Access Compliance Report

Public Rights-of-Way

(Curb Ramps)

Intersection ID: 12632	Main Street: SEIGLE_AV	Cross Street: SKYLINE_VIEW_WY	Location:	N
ADA ID: C82C832904FA	Ramp Type: BlendTrans1	Initial Pass/Fail: Fail	Overall Compliance: No	Severity Score: 1.25
Codes/Mitigation Info/Possible Solution		Field Measurements/Component Compliance

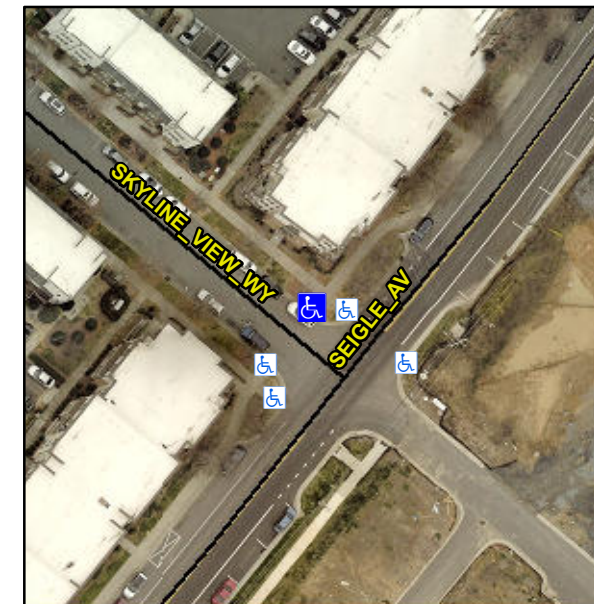
Not Found, R304.5.3

Compliance	Description	Data	Compliance	Description	Data
N/A	Ramp Length (in)	92.0	Yes	BlendTrans Slope (%)	4.9
Yes	Ramp Width (in)	71.5	No	BlendTrans XSlope (%)	2.6
N/A	Flare Type LT	N/A	N/A	Flare Type RT	N/A
N/A	Flare Slope LT (%)	N/A	N/A	Flare Slope RT (%)	N/A
N/A	Flare Traversable LT?	N/A	N/A	Flare Traversable RT?	N/A
N/A	Landing Length (in)	N/A	N/A	DWS Provided?	N/A
N/A	Landing Width (in)	N/A	N/A	DWS Contrast?	N/A
N/A	Landing Slope (%)	N/A	N/A	DWS Length (in)	N/A
N/A	Landing X Slope (%)	N/A	N/A	DWS Full Width?	N/A
N/A	Landing Curb? (Y/N)	N/A	N/A	DWS Offset (in)	N/A
N/A	Shared Landing?	N/A			
N/A	Gutter Ponding?	N/A	N/A	Gutter Slope (%)	N/A
N/A	Gutter Lip Ht (in)	N/A	N/A	Gutter X Slope (%)	N/A
N/A	Painted X Walk1?	No	N/A	Painted X Walk2?	N/A
	X Walk 1 Direction	To SW		X Walk 2 Direction	N/A
	X Walk 1 Width (in)	N/A		X Walk 2 Width (in)	N/A
	X Walk 1 Slope (%)	2.6		X Walk 2 Slope (%)	N/A
	X Walk 1 X Slope (%)	0.5		X Walk 2 X Slope (%)	N/A

N/A	Ramp inside XWalk1?	N/A	N/A	Ramp inside XWalk2?	N/A
	Road Slope (%)	0.5		Clear Space?	N/A
	Road X Slope (%)	2.6	N/A	Clear Space to XWalk (in)	N/A
N/A	Any Obstructions?	N/A	N/A	Storm Grate/Utility Hazard?	N/A
	Obstruction Type			Storm Grate/Utility Type	
		N/A			N/A
			Yes	Surface Condition? (G/P)	Good
			No	Curb Slope (%)	14.3

Remove & Replace Curb Ramp With Two New Directional Ramps or Equivalent.
